VILLAGE OF ESTERO
PLANNING ZONING AND DESIGN BOARD MEETING
PACKET
JULY 21, 2026, 04:30 PM

- a. Leo Brown Group/Mission Grove of Estero, Plaza Del Sol, Parcel G -- East (Pending Application) (District 4) 10251 Arcos Avenue, north of Culver's and Auto Zone.**

a. Coconut Point Developers LLC -- Developer Repaint Project and Revised Signage Plan DCI2026-E001 (District 6)

MISSION GROVE | **ARCHITECTURAL INTENT**

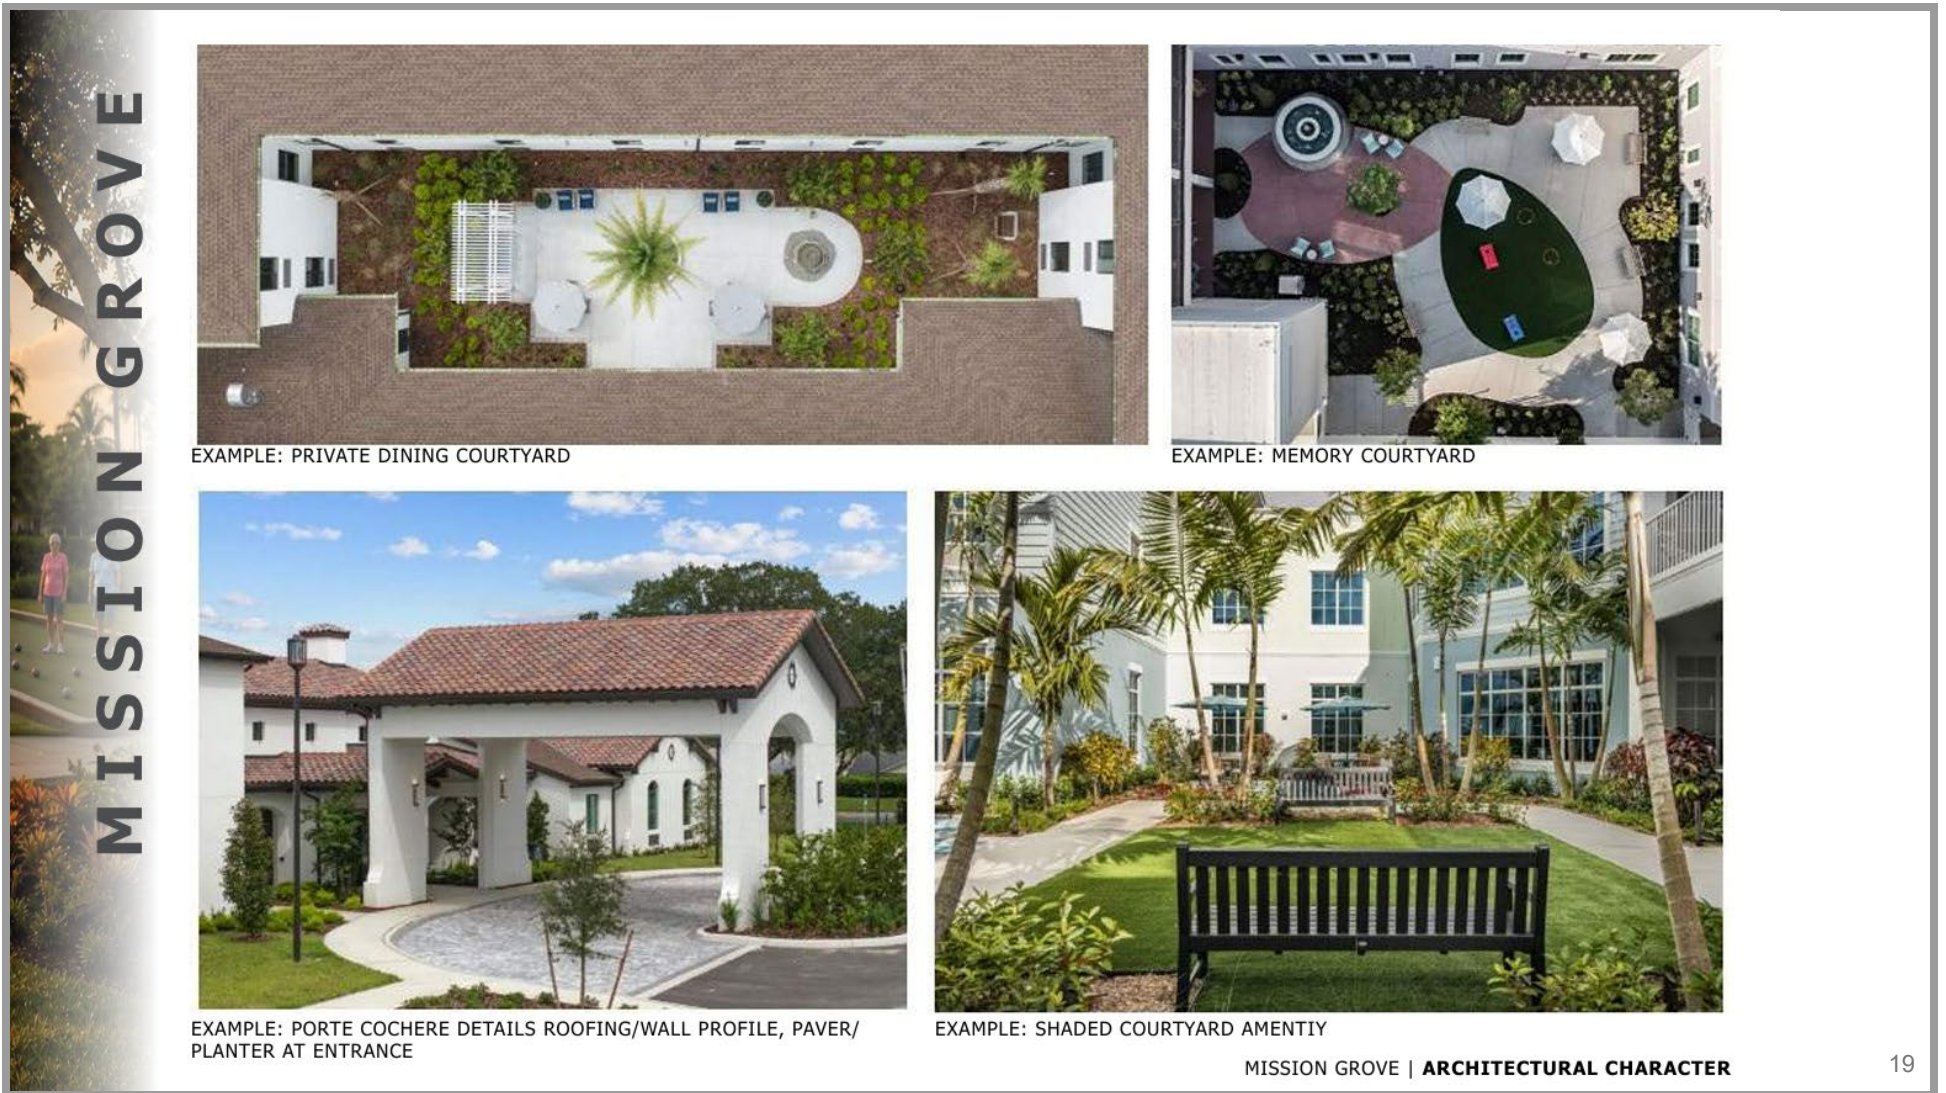
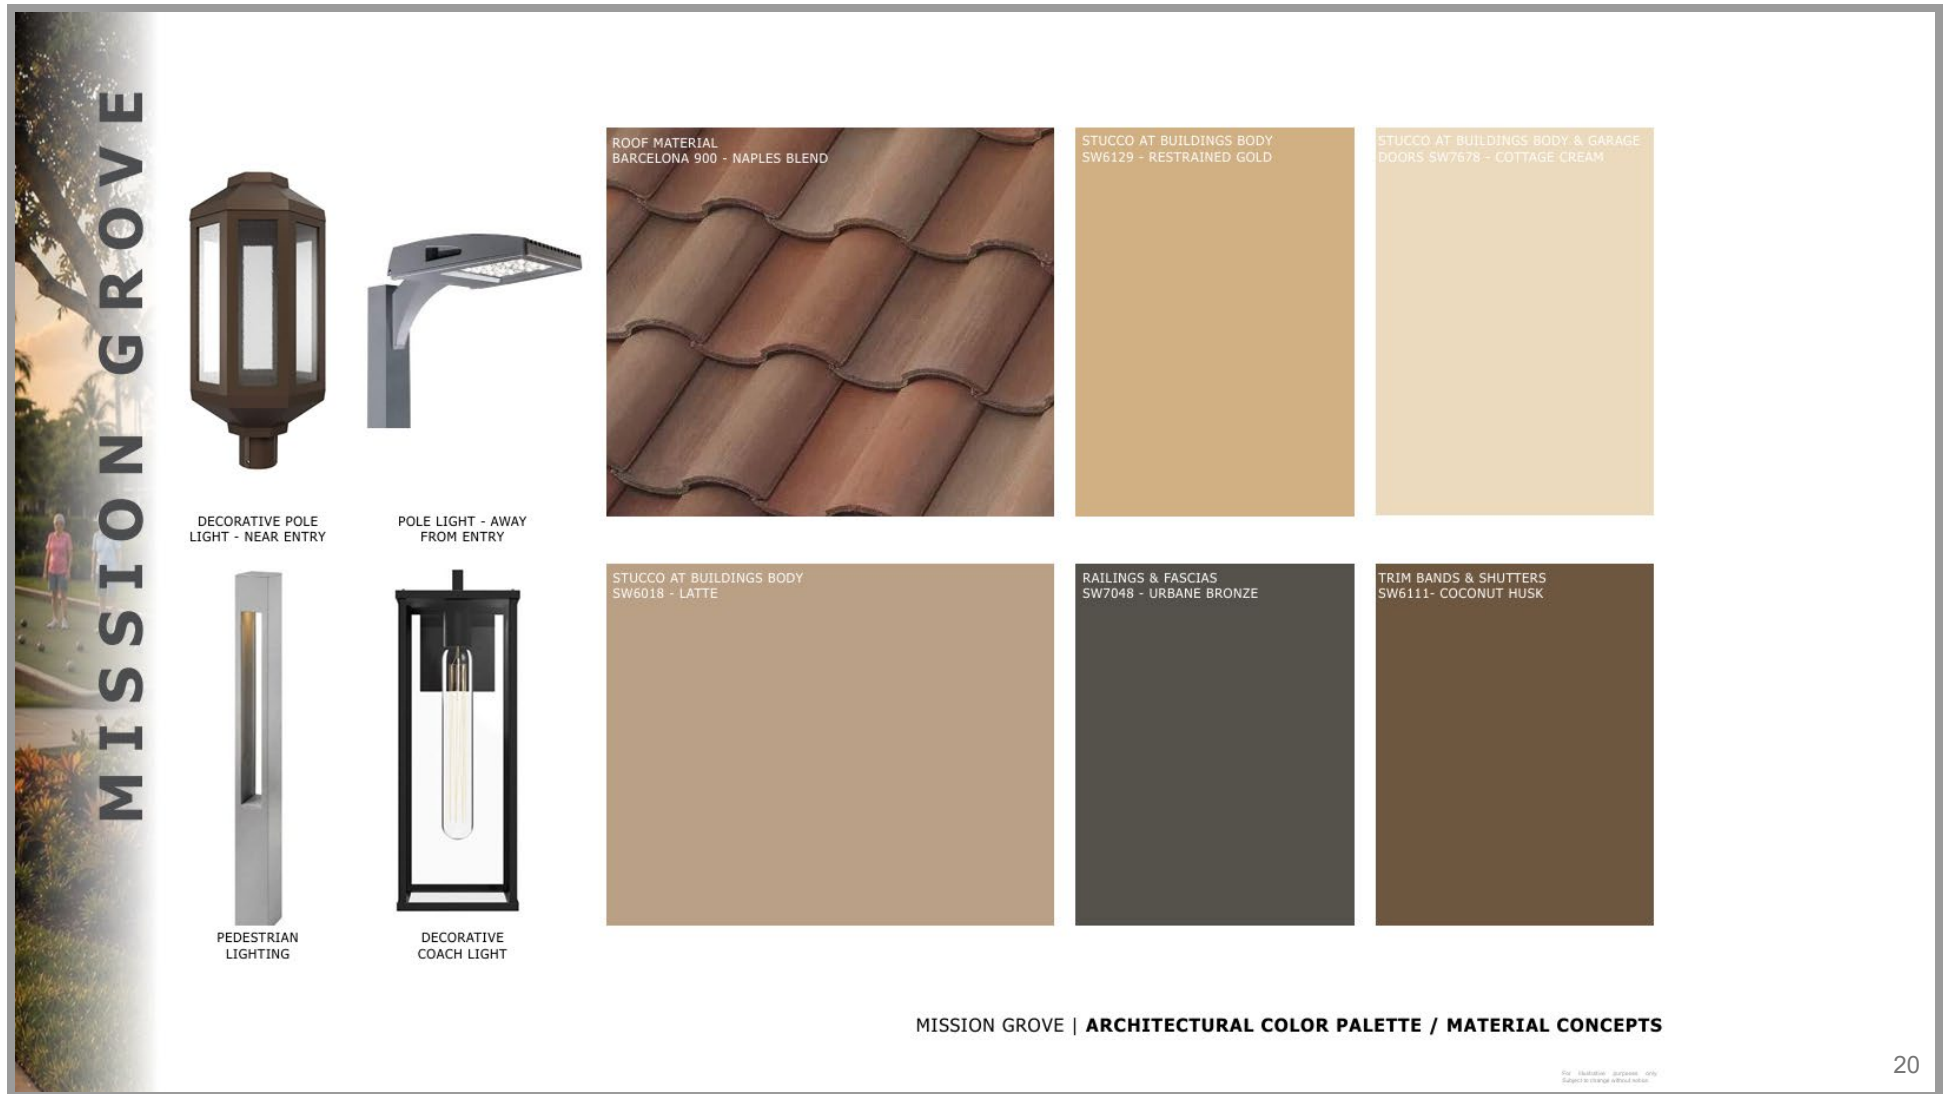
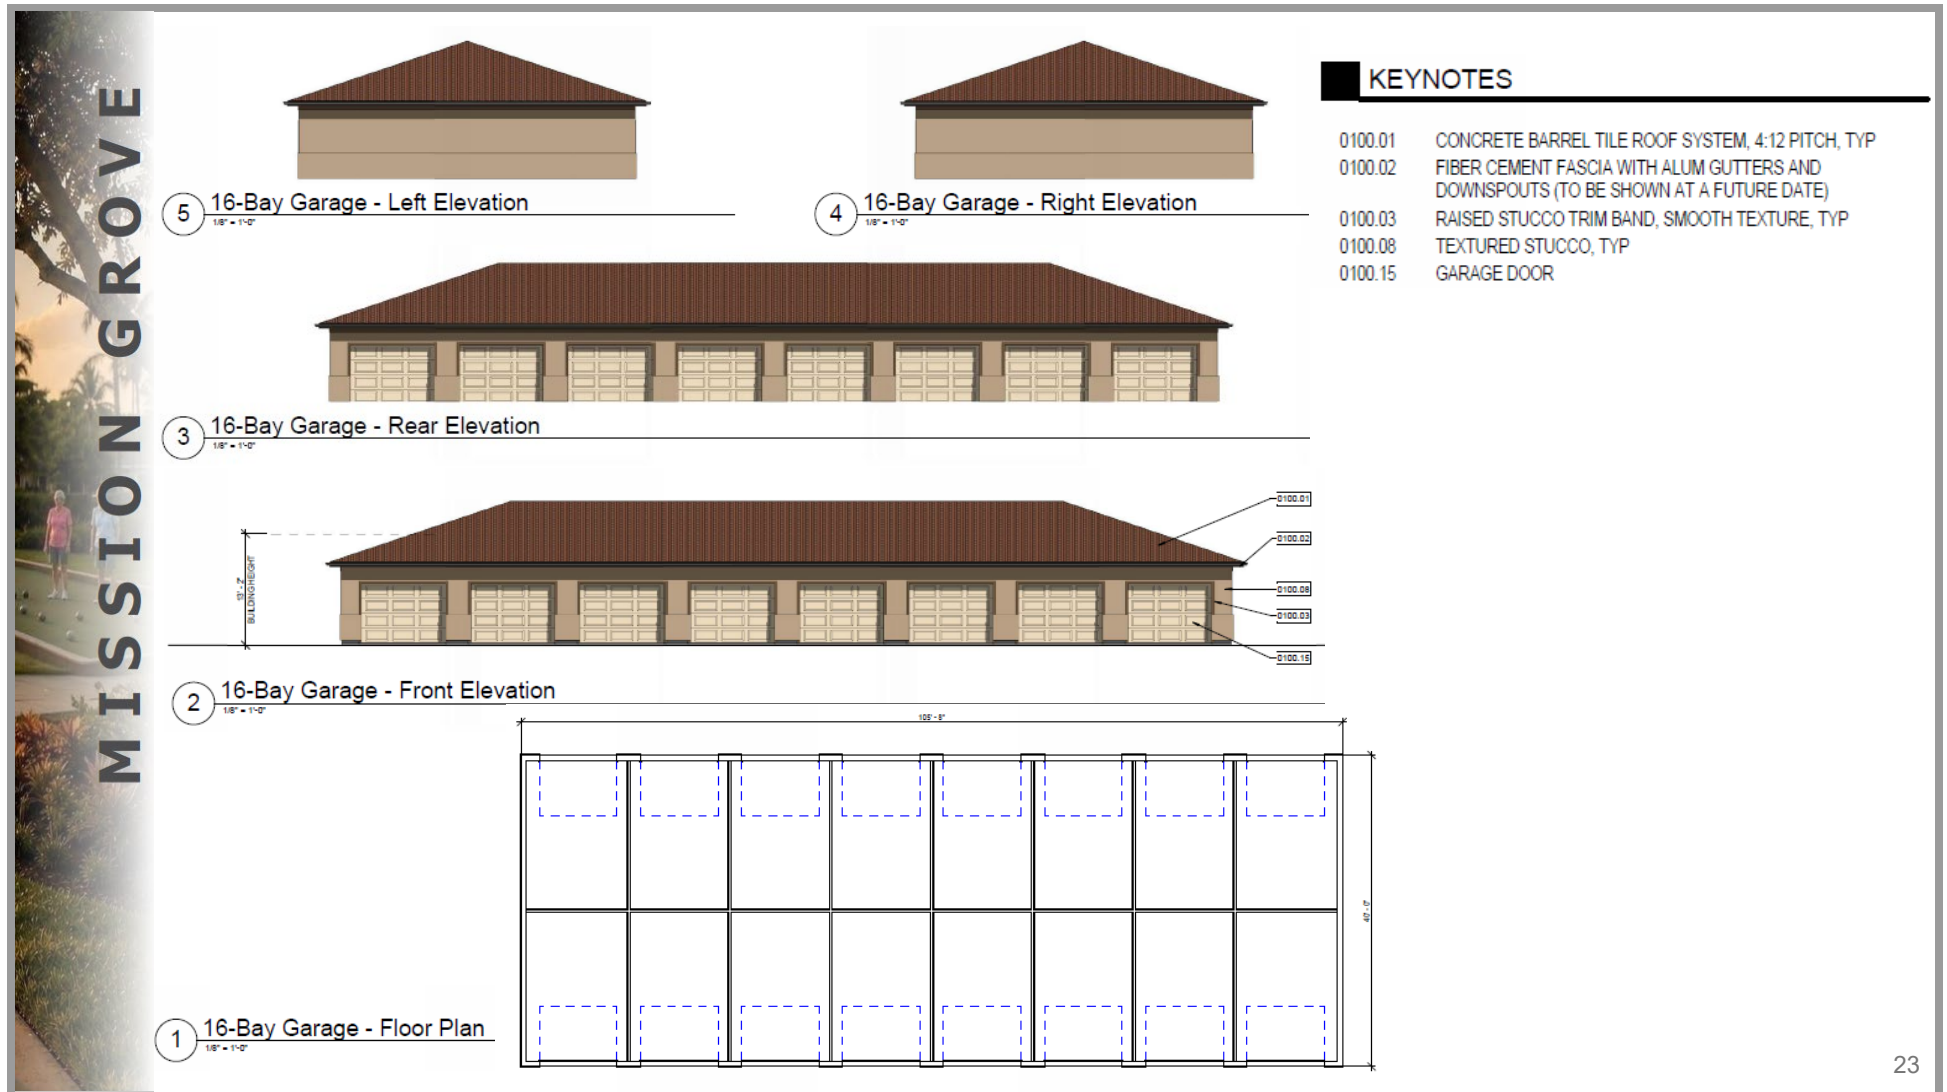
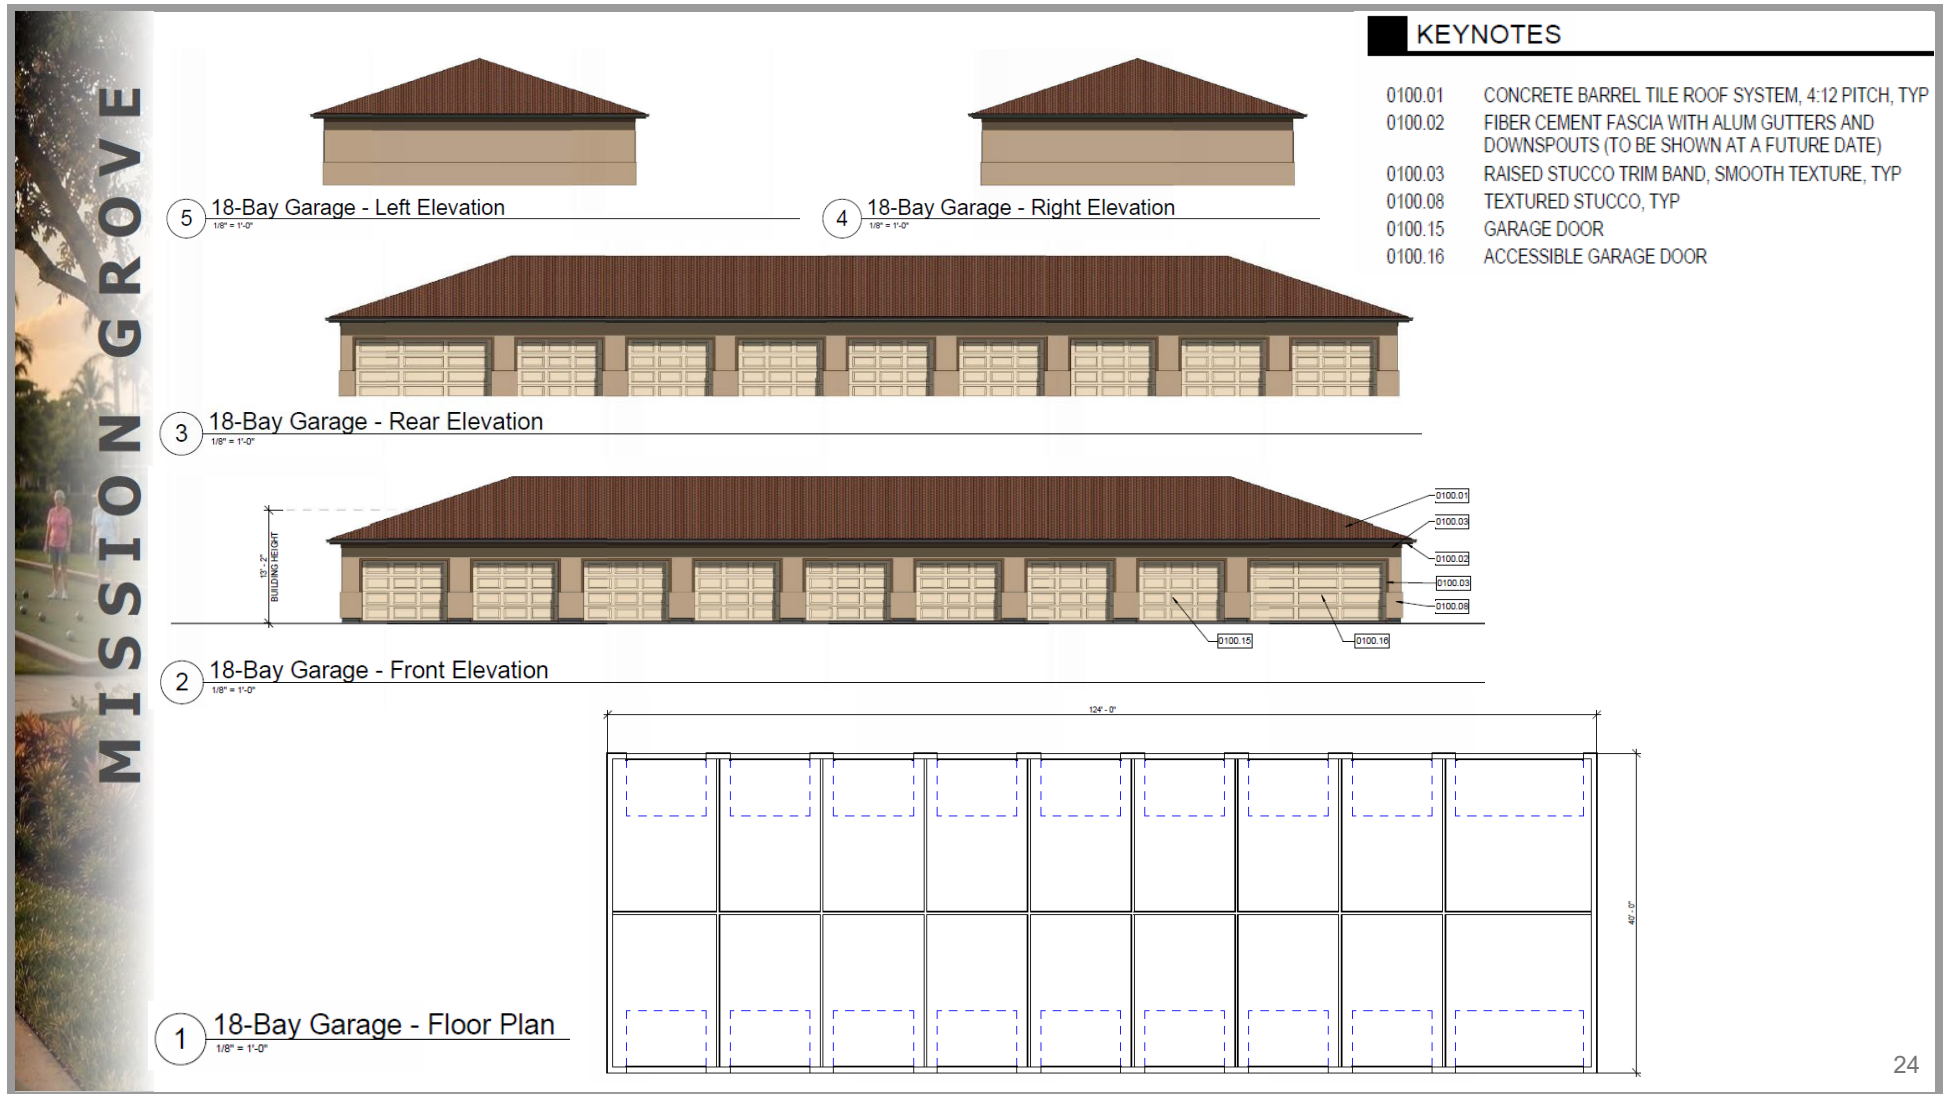
4:58:44PM PERHAPS MORE WORK IN DESIGN MIGHT BE HELPFUL TO GET
 GREATER
 4:58:49PM EXPRESSION, MORE SHADOW, MORE DETAIL, ET CETERA.
 4:58:52PM THE BUILDING IS RATHER PLAIN, RIGHT?
 4:58:55PM AND, OF COURSE, IN ESTERO, WE DON'T WANT BUILDINGS
 4:58:58PM PREDOMINANTLY ONE COLOR.
 4:59:00PM YOUR ELEVATIONS, THE WHOLE THING LOOKS BEIGE.
 4:59:03PM BEIGE ON BEIGE ON BEIGE, DIFFERENT SHADES.
 4:59:06PM AGAIN, THE RENDERINGS VERSUS THE ELEVATIONS I THINK THE
 4:59:11PM 3Ds ARE ALWAYS BETTER TO SHOW WHAT YOU'VE GOT.
 4:59:14PM OFTENTIMES THE ELEVATIONS JUST DON'T REALLY SHOW IT WELL.

5:00:30PM IT NEEDS A LITTLE MORE DETAIL AND NEEDS TO BE BROKEN UP A
 5:00:33PM LITTLE BIT MORE SO THAT IT'S MORE DISTINCTIVE PARTS OF THE
 5:00:36PM BUILDING RATHER THAN ONE BIG BLACK BUILDING.

5:03:31PM BREAKING THE EAVE LINE WITH LITTLE LARGER ELEMENTS.
 5:03:34PM LITTLE TALLER, BRINGING THE COLORS ALL THE WAY --
 5:03:40PM >>Jim Wallace: FOUR FEET INSTEAD OF TWO FEET.
 5:03:48PM >>Glen Baurhyte: ANOTHER ROOF LEVEL CHANGE KIND OF HIDDEN BY
 5:03:50PM A PALM TREE IN THIS VIEW.
 5:03:52PM >>Al Paivandy: THE OTHER CORNER HAS ALL OF THE ELEMENTS THAT
 5:03:56PM APPEARS TO BE EVERYBODY IS LOOKING FOR, THE VARIATION IN

5:05:26PM >>Glen Baurhyte: YES.
 5:05:28PM HAVEN'T HAD THE LANDSCAPE TEAM DO THEIR THING YET ON THIS.
 5:05:32PM I KNOW RIGHT HERE WAS SPACE FOR A SHADE STRUCTURE THAT THE
 5:05:36PM RENDER DIDN'T SHOW.
 5:05:37PM THE TREES ARE NOT FINAL.
 5:05:42PM >>Jim Wallace: THE NORTH AND SOUTH ELEVATION HAVE MUCH MORE
 5:05:46PM INTEREST.
 5:05:49PM WHEN YOU GET TO THE WEST, IT LOOKS LIKE PRISON.
